# **Safety Evaluation Report**

Related to the Early Site Permit  
Application in the Matter of  
PSEG Power, LLC and PSEG  
Nuclear, LLC for the PSEG Early  
Site Permit Site

Docket No. 52-043

**PSEG Power, LLC and PSEG Nuclear, LLC**

**Figure 2.3-8 Site Utilization Plan (Reproduced from SSAR Figure 1.2-3)**

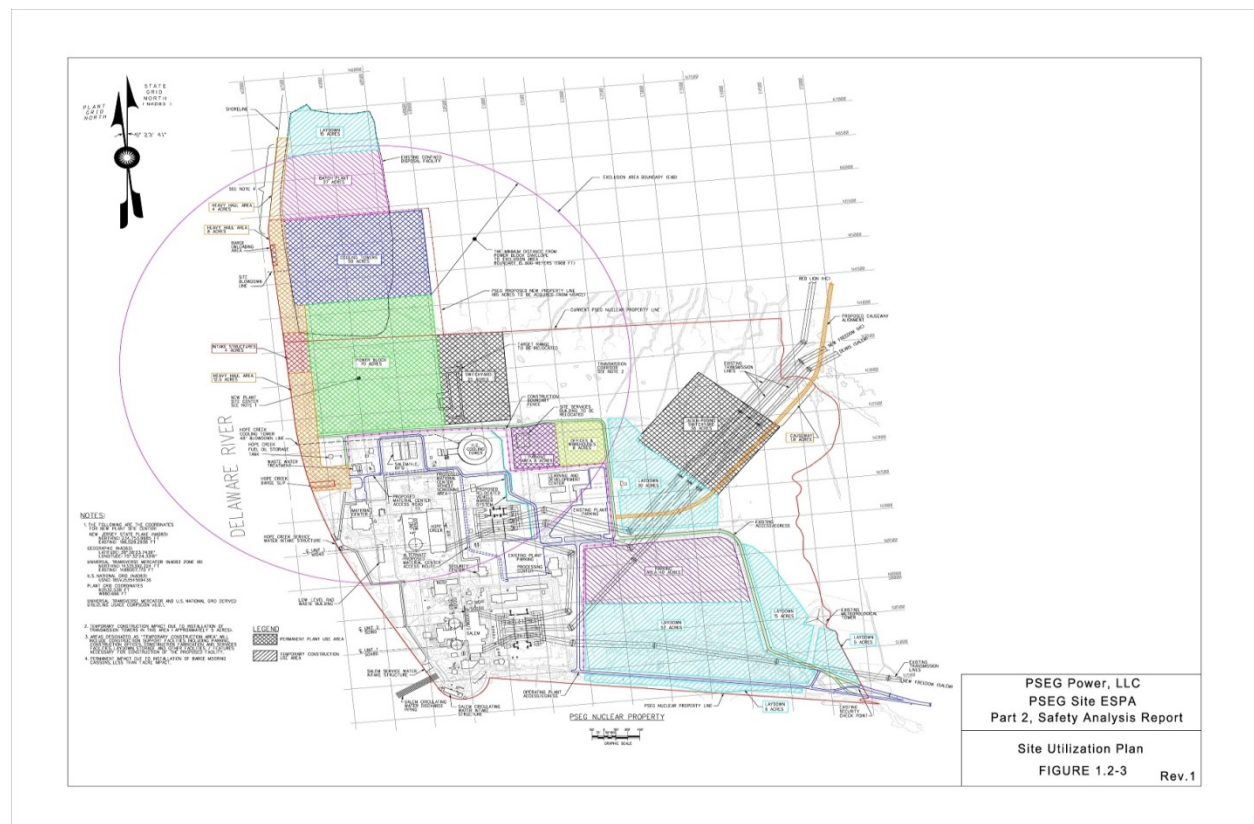
Coordinates for the power block reference point are provided in geodetic and UTM systems. SSAR Section 2.1.1.2 (Paragraph 2) and SSAR Figure 1.2–3 identified the UTM coordinates without units, which appear to be measured in feet. Therefore, in RAI 9, Question 02.01.01-1, the staff requested that the applicant annotate the list of UTM coordinates in the SSAR and to do so in the marginal notes on SSAR Figure 1.2-3 with the correct units of measure. In a March 21, 2011, response to RAI 9, Question 02.01.01-1, the applicant provided a revision to

SSAR text in Section 2.1.1.2 and SSAR Figure 1.2-3 with the English unit of measurement (in feet), and committed to revise the SSAR with this information. The staff reviewed the applicant's response and subsequently confirmed that SSAR Revision 1, submitted on May 21, 2012, contained the information as committed in the RAI response. Accordingly, the staff finds the applicant's response acceptable and considers RAI 9, Question 02.01.01-1, resolved.

The PSEG proposed Exclusion Area Boundary (EAB) is a circle at least 600 m (1968 ft) from the edge of the power block area in all directions as shown in SSAR Figure 1.2-3. As shown in SSAR Figure 2.1-23, the proposed EAB extends beyond the PSEG Site property line to west (into the Delaware River) and to the north and northeast. The total area that the EAB encompasses is 3.0 km<sup>2</sup> (743 acres), of which 0.91 km<sup>2</sup> (224 acres) is in the Delaware River and 1.17 km<sup>2</sup> (288 acres) is in land that PSEG currently owns. PSEG will own an additional 0.344 km<sup>2</sup> (85 acres) of land when it completes property acquisition with the USACE. The land within the EAB that PSEG does not own consists of 0.59 km<sup>2</sup> (146 acres), which the Federal Government owns. No public roads, railroads, or structures other than the existing PSEG power plant facilities are located within any part of the EAB. From the information in SSAR Section 2.1.1.2 and SSAR Figure 1.2-3, it appears to the staff that the additional 0.344 km<sup>2</sup> (85 acres) of land is bounded by the area, as described in "PSEG Proposed New Property Line." In RAI 9, Question 02.01.01-2, the staff requested that the applicant distinguish the different areas in EAB and clarify them in SSAR Section 2.1.1.2 and SSAR Figure 1.2-3 accordingly. In a March 21, 2011, response to RAI 9, Question 02.01.01-2, the applicant provided clarification along with proposed revisions to SSAR Section 2.1.1.2 and SSAR Figure 1.2-3. The staff reviewed the response and found the applicant's clarification appropriate and adequate, and therefore acceptable. The staff also confirmed the inclusion of the proposed revisions in SSAR Section 2.1.1.2 and SSAR Figure 1.2-3, Revision 1, submitted on May 21, 2012. Accordingly, the staff considers RAI 9, Question 02.01.01-2, resolved.

The land boundary, on which technical specification limits for release of gaseous radioactive effluents are based, is the PSEG Site property line shown in SSAR Figure 1.2-3. The minimum distance from the center point to the property line is 265.8 m (872 ft) in the west direction. The staff notes this suggests that it is one of the site boundary receptor locations being considered for dose evaluation. However, in a September 9, 2011, response to RAI 35, Question 02.03.05-04 (on SSAR Section 2.3.5, "Long-Term Atmospheric Dispersion Estimates for Routine Releases"), the applicant stated that although X/Q and D/Q values have been calculated for all 16 radial directions at the PSEG Site boundary including the PSEG Site boundary location receptor addressed above at 265.8 m (872 ft) in the west direction, sectors adjacent to the Delaware River (sectors SE to NW in clockwise direction) are not considered in the dose evaluations. Therefore, in follow up RAI 49, Question 02.01.01-3, the staff requested that the applicant update the information in SSAR Section 2.1.1.3 for clarity and consistency. In a February 24, 2012, response, the applicant provided information clarifying and justifying

The staff reviewed the site area map in the SSAR (Figure 1.2-3) for the proposed PSEG Site to verify that the distance from the proposed power block to the boundary line of the exclusion area meets the guidance in NUREG-0800, Section 2.1.1. Based on its review of the information in the SSAR, and confirmatory review of prominent, natural, and manmade features of the area as found in publicly available documentation, the staff finds the information provided by the applicant with regard to the PSEG Site location and description adequate and acceptable.

**Figure 2.4.6-1 Major faults in the Greater Antilles region**

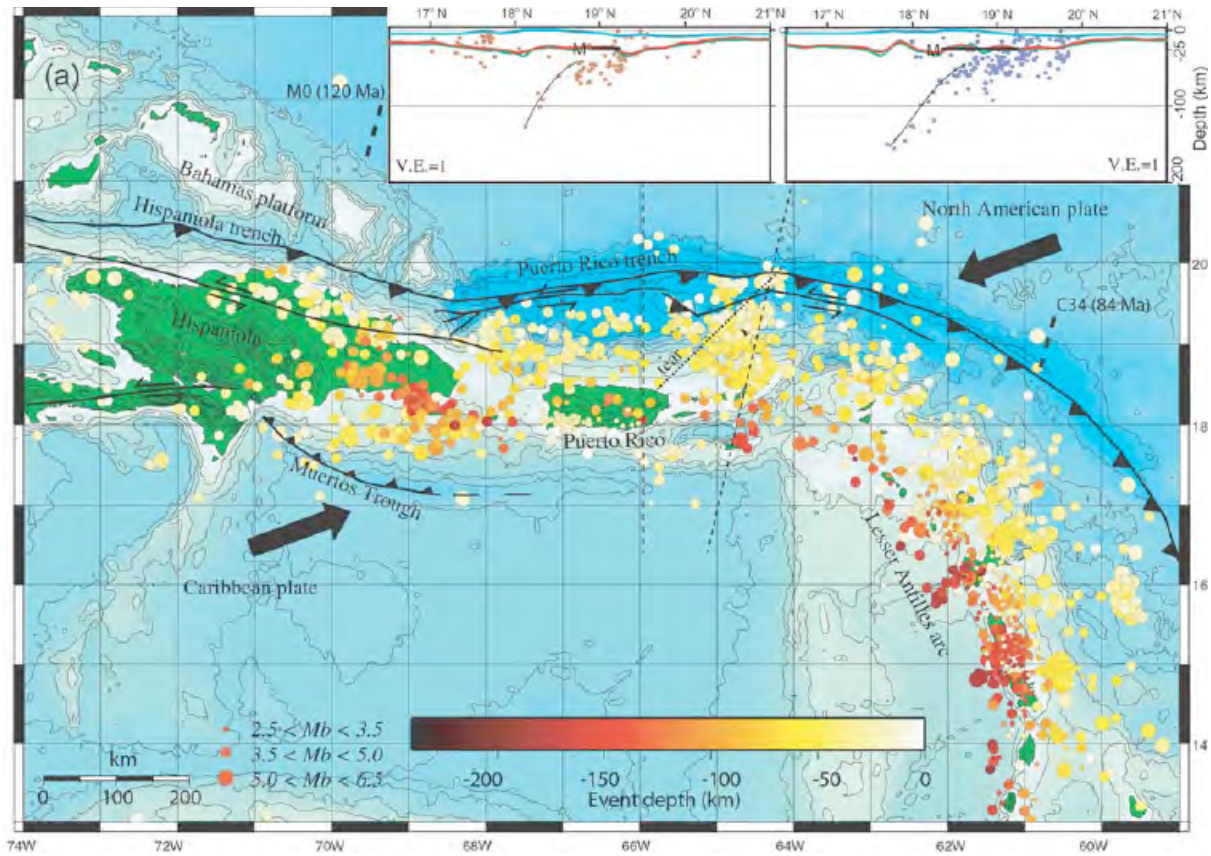
In RAI 20, Question 02.04.06-2, the staff requested that the applicant provide an updated figure showing a maximum slope angle of 0.3 degrees and an updated figure/reference to related work in SSAR Section 2.5.5 in a revision of the SSAR. In a May 11, 2011, response to RAI 20, Question 02.04.06-2, the applicant stated that SSAR Figure 2.4.6-1 has a scale of slope (i.e., dimensionless rise over run) ranging from 0 to 0.002. At the maximum scale value, the angle of the slope would equal 0.115 degrees. To minimize any further confusion over this figure, the applicant revised the figure to have a dimensioned scale in angular degrees. The staff verified that Revision 1 of the ESP application (May 21, 2012) contains the applicant's committed change.

Figure 2.4.6-1 shows the naturally occurring angular topography slopes on a grid in the vicinity of the PSEG Site, and shows a maximum slope value of  $0.3^{\circ}$  occurring inland of the site. Stability analysis will be conducted during the COLA phase of the project, and will include consideration of failure surfaces that extend into the Delaware River adjacent to the site as discussed in SSAR Subsection 2.5.5.1.

SSAR Figure 2.4.6-1, provided in Enclosure 3 of the applicant's May 11, 2011, response to RAI 20, Question 02.04.06-2, was revised by the applicant and submitted in a May 31, 2011, supplement to the May 11, 2011, response. The applicant committed to revise the SSAR to provide a scale in angular degrees. The staff confirmed that Revision 1 of the ESP application (May 21, 2012) contains the applicant's committed changes. Accordingly, the staff considers RAI 20, Question 02.04.06-2 resolved.
